DRB Application No.: 08DRB-70456

Project Name: RICHFIELD PARK

**CITY OF ALBUQUERQUE
PLANNING DEPARTMENT
October 10, 2007
DRB Comments**

RE: Lots 4 & 5, Richfield Park Subdivision/spbp

SITE PLAN & TRAFFIC CIRCULATION LAYOUT

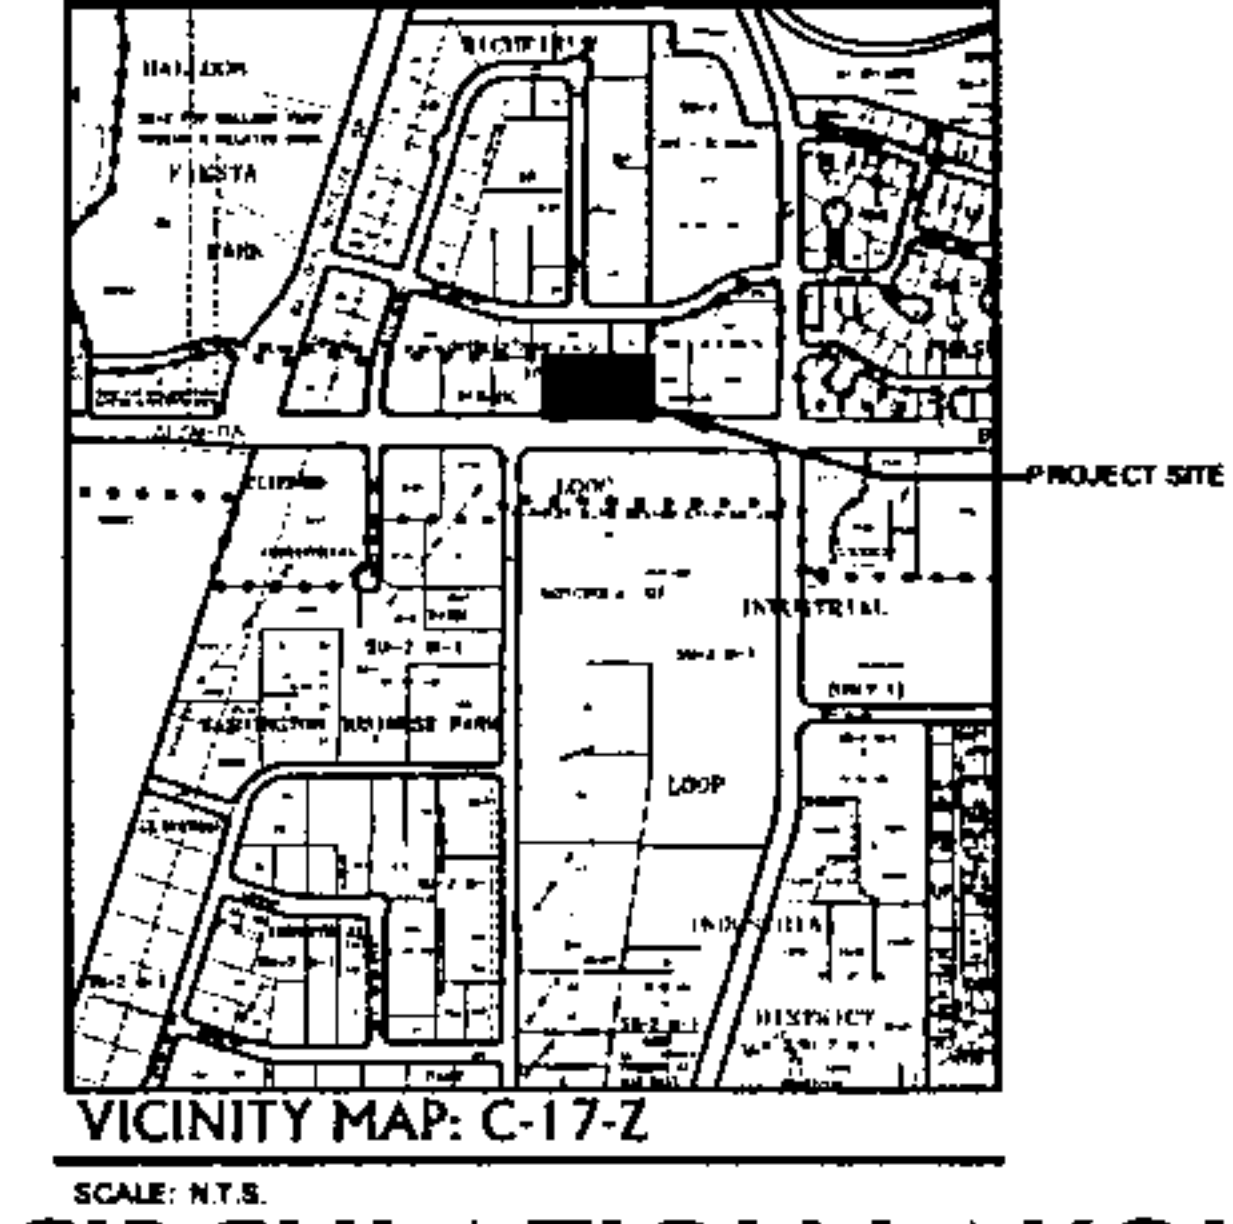
There is about 20 feet from the property line to the right of way line, none of which shows landscaping.

→ The required 30 foot front yard setback must be met. A variance application is possible if the building encroaches on the 30 feet and a correction to the plan can't occur.

✓ 2. Page 27, (E)(2). The building must be separated from off-street parking areas with landscaping and 6 foot wide sidewalks. The sidewalk around the building must be 6 feet. This should be indicated in Note 12 on the site plan sheet.
